# Access Compliance Report

## Public Rights-of-Way

Intersection ID: 12316	Main Street: ASHLEY_RD	Cross Street: GREENLAND_AV	Location: NW
ADA ID: 9EF0A0769484	Ramp Type: IslandPerp	Initial Pass/Fail: Fail	Overall Compliance: No
Codes/Mitigation Info/Possible Solution		Field Measurements/Component Compliance	
Severity Score: 10

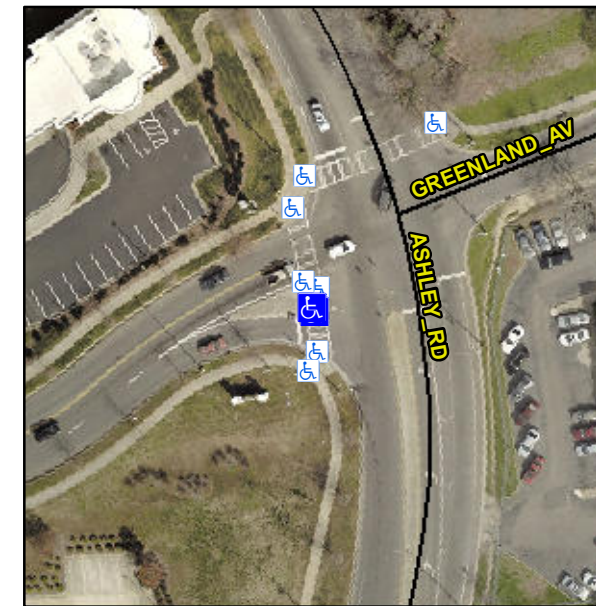
**R304.5.1**

Compliance	Description	Data	Compliance	Description	Data
N/A	Ramp Length (in)	30.0	Yes	Ramp Slope (%)	5.9
No	Ramp Width (in)	47.5	Yes	Ramp XSlope (%)	2.6
N/A	Flare Type LT	N/A	N/A	Flare Type RT	N/A
N/A	Flare Slope LT (%)	N/A	N/A	Flare Slope RT (%)	N/A
N/A	Flare Traversable LT?	N/A	N/A	Flare Traversable RT?	N/A
N/A	Landing Length (in)	N/A	N/A	DWS Provided?	N/A
N/A	Landing Width (in)	N/A	N/A	DWS Contrast?	N/A
N/A	Landing Slope (%)	N/A	N/A	DWS Length (in)	N/A
N/A	Landing X Slope (%)	N/A	N/A	DWS Full Width?	N/A
N/A	Landing Curb? (Y/N)	N/A	N/A	DWS Offset (in)	N/A
N/A	Shared Landing?	N/A			
N/A	Gutter Ponding?	N/A	N/A	Gutter Slope (%)	N/A
N/A	Gutter Lip Ht (in)	N/A	N/A	Gutter X Slope (%)	N/A
N/A	Painted X Walk1?	Yes	N/A	Painted X Walk2?	N/A
	X Walk 1 Direction	To S		X Walk 2 Direction	N/A
N/A	X Walk 1 Width (in)	116.0	N/A	X Walk 2 Width (in)	N/A
	X Walk 1 Slope (%)	0.5		X Walk 2 Slope (%)	N/A
	X Walk 1 X Slope (%)	3.4		X Walk 2 X Slope (%)	N/A

**Remove & Replace Entire Ramp.**
